2nd Addendum letter for MOD - TPS

ECS Project # 03-216630.00

Re: Response to Questions- Risk Based Site Cleanup and Disposal Plan  
Thomas Prince School  
170 Sterling Road  
Princeton, MA 01541

**Figure 1: Typical Exterior Vent Structure: 100 Wing Classrooms.**

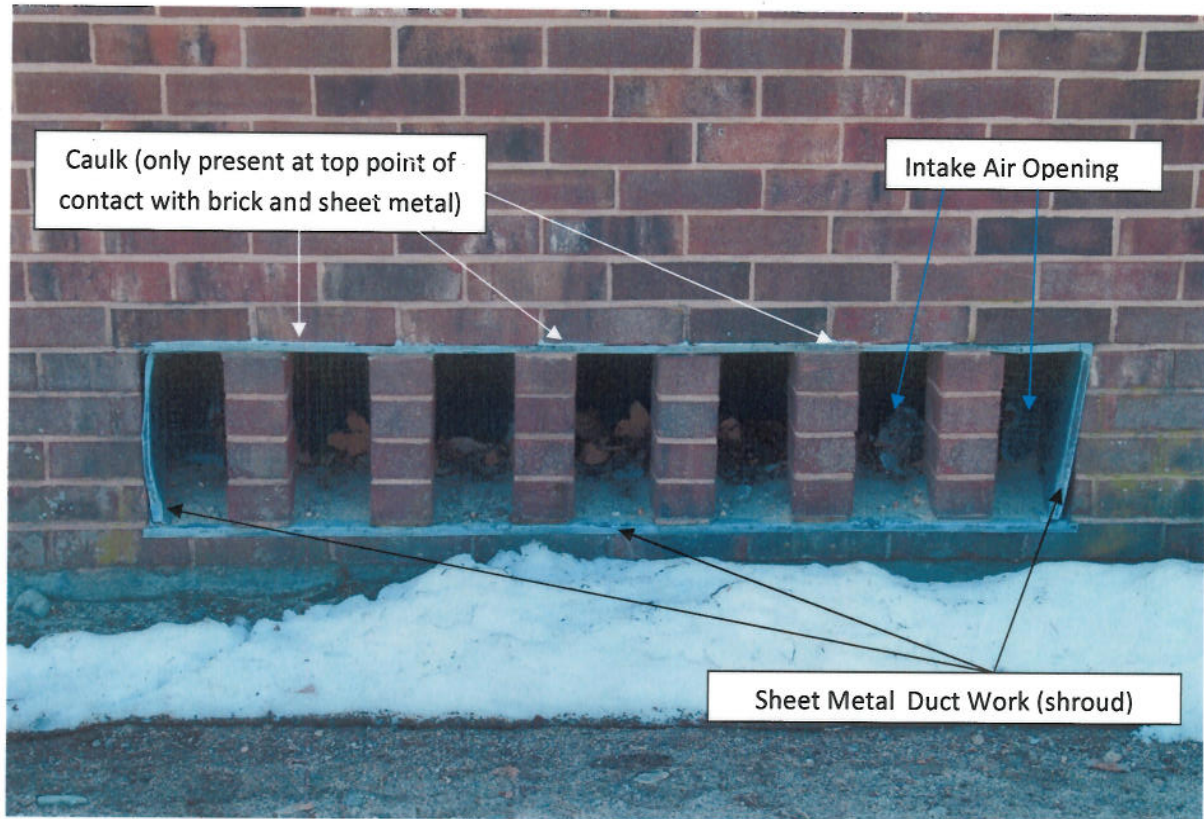
**Air Intake Vents – 100 Wing Classrooms** – Prior to and following the meeting which I attended at the school yesterday, ECS and TEI closely inspected the air intake vents for the subject 100-Wing classrooms. See the attached photo, Figure 1, for a depiction of a typical vent for the subject 100-Wing Classrooms.

A typical vent opening is 54 inches wide by 8 inches in height. It is located on the bottom vertical side of the building and does not contain a louvered plate over its front but rather is open in the front, divided by several, eight inch high by two inch wide brick columns. Sheet metal ducting lines the interior of the vent and is supported in the front opening by the brick columns. The sheet metal ducting extends contiguously into the unit ventilator. Where it comes in contact with the exterior brick face of the building facade, it is crimped at a 90° angle to overlap the exterior building brick face by approximately ½ inch on all four sides. It was determined that caulking is only present at the top of the ducting of each exterior vent opening where the sheet metal duct work comes in contact with the brick, i.e. the side and

bottom joints do not contain caulk and no remnants of caulk were observed. The unit ventilator draws its room dilution air from this vent opening.

Following is the plan, in order of operation, to address these exterior vent openings as part of the previously submitted modification.

- 1) All exterior caulk associated with the vents will be removed (this will be approximately 22.5 linear feet based on caulk only being present at the top of the vent as recently confirmed);

- 2) The ½ inch of sheet metal that is crimped at a 90° angle parallel with the brick face, on all four sides, will be bent back so that it is perpendicular to the brick face. This will provide access to the small gap between the brick and the sheet metal for cleaning and epoxy coating;

- 3) The gaps between the sheet metal and brick will be suctioned with a HEPA vacuum to remove loose residual debris that may be present;
- 4) The readily accessible inner surfaces of the duct work, at and within the opening of the air vent, will be cleaned via HEPA vacuum to remove dust, dirt or debris;

- 5) The readily accessible surfaces of the sheet metal duct work and brick that were in contact with the caulking will be cleaned via wet wipe methods;

- 6) The readily accessible inner surfaces of the duct work, at and within the opening of the air vent, will be cleaned via wet wipe methods;
- 7) Two coats of epoxy will be applied to the accessible surfaces of the brick to a distance of eight inches (four brick widths) from each side of the vent, consistent with the previously approved distance for the 200-Wing rooms). In addition, two coats of epoxy will be applied to the brick surfaces that are perpendicular to the brick face wall at a distance of approximately ½ to 1 inch at the corners of the brick surface that extend below the metal duct work;

- 8) The edges of the sheet metal duct work, adjacent to the exterior brick building façade, will be bent back to their original positions such that approximately ½ inch of sheet metal will cover the edges of the epoxy coated brick at the openings of the air vents.

**Figure 2: Typical Exterior Louvered Vent Structure: 200 Wing Classrooms.**

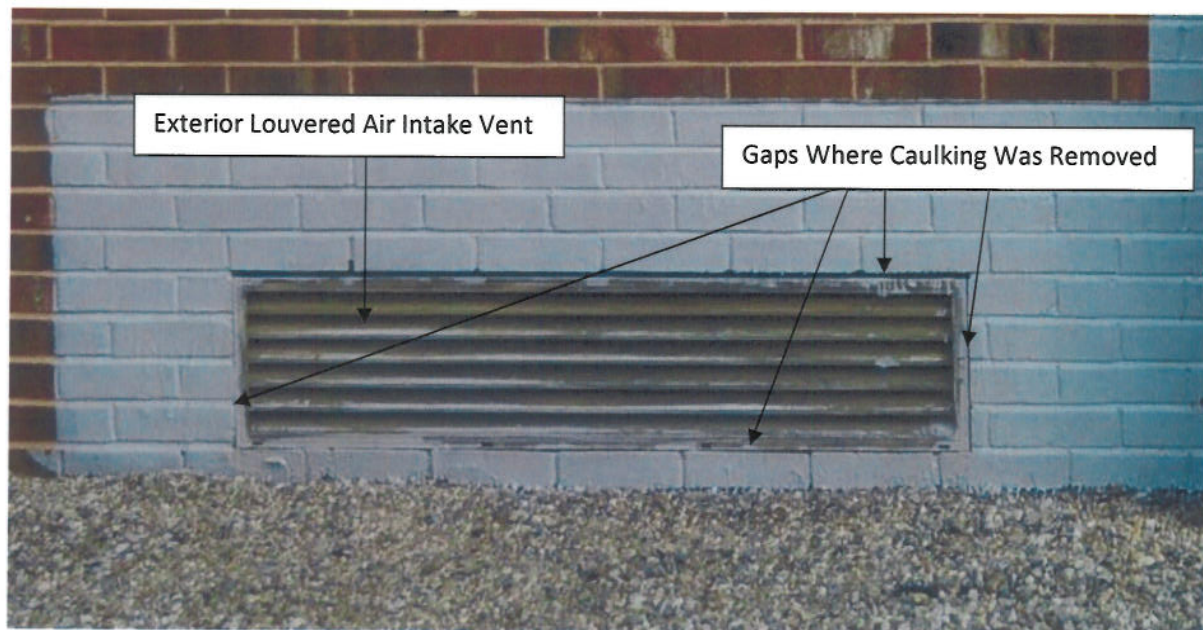
**Air Intake Louvered Vent Covers – 200 Wing Classrooms** – As we discussed on Tuesday, the approved Risk Based Site Cleanup Plan for the 200-Wing exterior metal louvered air intake vent covers provided for the removal and replacement of the covers (section 4.4, bullet one of the February 13, 2012 Risk Based Cleanup Plan). Due to an oversight, the vent covers were not removed. Following the meeting at the school yesterday, ECS and TEI closely inspected several of the exterior louvered air intake vent covers for the 200-Wing classrooms. Review of field notes and a discussion with the TEI Field Supervisor were also performed to confirm the actions that were taken to address the metal louvered vent covers. Based on a review of available information and discussions with TEI, it was confirmed that the following actions were taken in response to the exterior louvered vent covers:

- a) All visual exterior caulking was removed;
- b) The outer sides of the louvered vent covers (sides facing away from the building) had been cleaned via HEPA vacuum and wet wipe methods (the inner sides of the vent covers (facing the building) had not been cleaned);

- c) Two layers of epoxy were applied to the brick face within 8 inches of each side of the louvered vent covers.

As a modification to the plan, ECS proposes to collect three wipe samples, per required EPA methodology, and submit the samples for analysis via EPA Methods 3540C and 8082 for PCB's. It is proposed that one sample each be collected from three of the six existing inner sides of the louvered vent covers. If the result of a wipe sample for a particular louvered vent cover is greater than 1 ug/100cm<sup>2</sup> PCB, that louvered vent cover will be removed and cleaned via HEPA vacuum and wet wipe methods or replaced with a new cover.

If the cleaning option is selected, upon cleaning, another wipe sample will be collected from the inner side of the vent. If the sample result remains greater than 1 ug/100cm<sup>2</sup> PCB, the louvered vent cover will again be cleaned via HEPA vacuum and wet wipe methods or replaced with a new cover. Any cover that produces results less than 1 ug/100cm<sup>2</sup> PCB will remain in place or be reinstalled (if it was removed for cleaning and re-sampling). This procedure will continue until either a result of less than 1 ug/100cm<sup>2</sup> PCB is obtained for a particular vent cover or until a new cover is obtained. The decision to resample or replace a cover will be made by the Town of Princeton. See the attached photo, Figure 2, for a depiction of a typical exterior louvered vent cover for the 200-Wing Classrooms.
